**RE: MCPHILLAMYS GOLD PROJECT SSD-9505**

The Belubula Headwaters Protection Group formally OBJECTS and OPPOSES the abovementioned proposal, that of the McPhillamys Gold Project, SSD-9505. We confirm our group has not made any political donations.

## McPhillamys Gold Project with Asbestos Potential Overlay

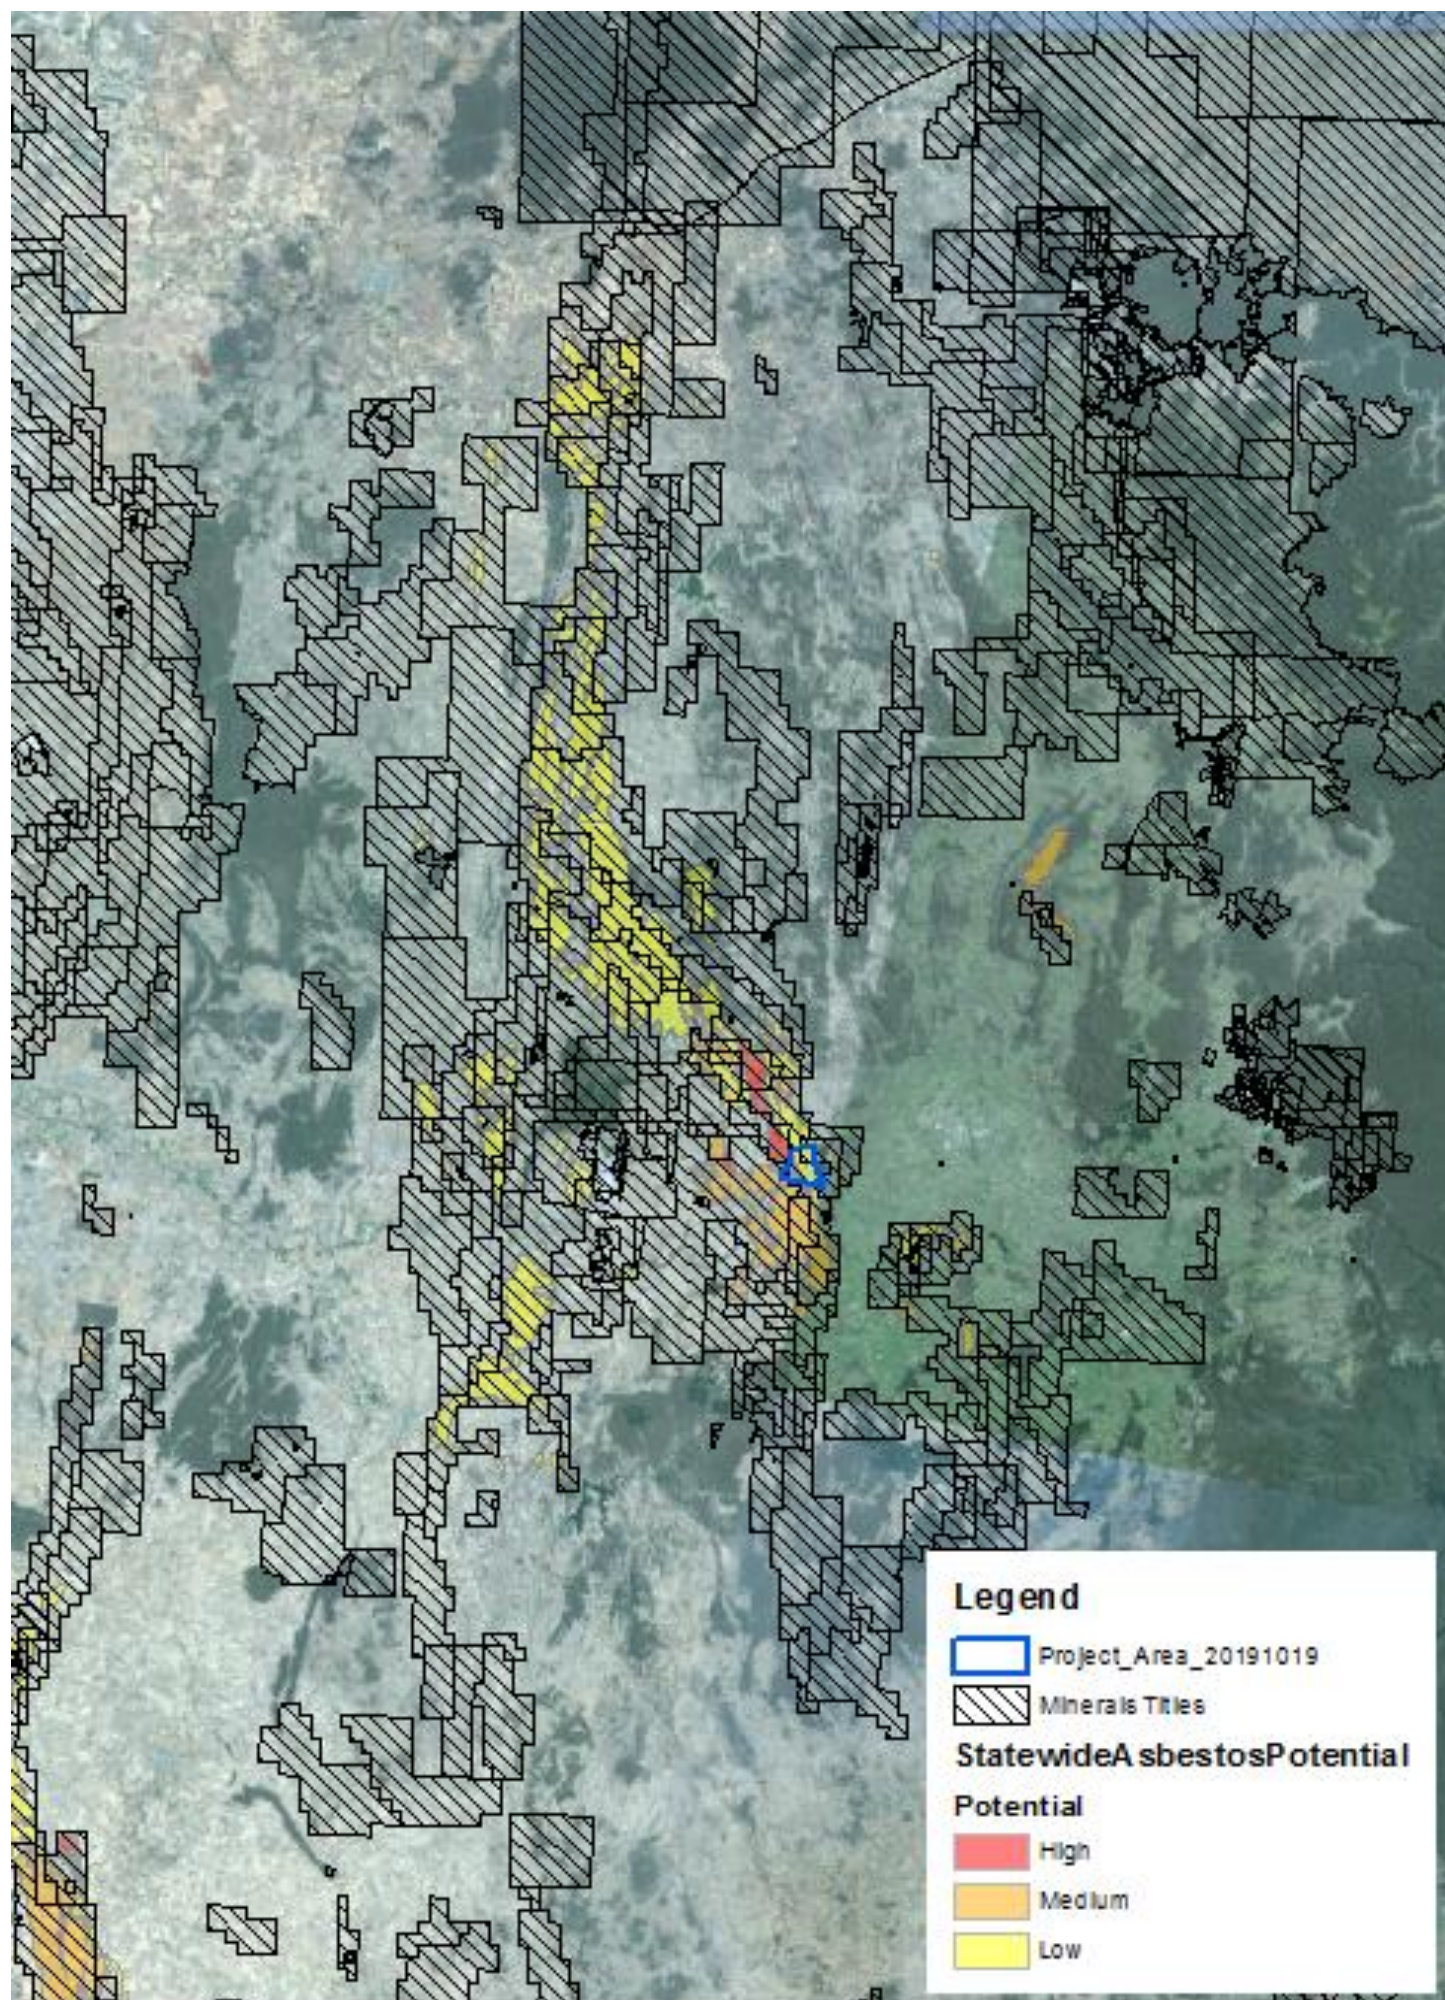
On page 194 of the main report of the EIS it is stated “*The Anson Formation, over which the disturbance footprint associated with the mine development lies, has been categorised as having low asbestos potential.*” And also on page 211 it states “*the project area contains a low risk of the presence of naturally occurring asbestos.*” Therefore in two places in the EIS Regis has stated that there is only low asbestos potential. The following maps below however, overlay the Department’s map of potentially naturally occurring asbestos with the Project and were prepared by the Environmental Defenders Office (EDO). These maps show that there are potentially medium and high potential levels over the mine footprint. **Why has Regis omitted this very important and obvious information in the EIS?**
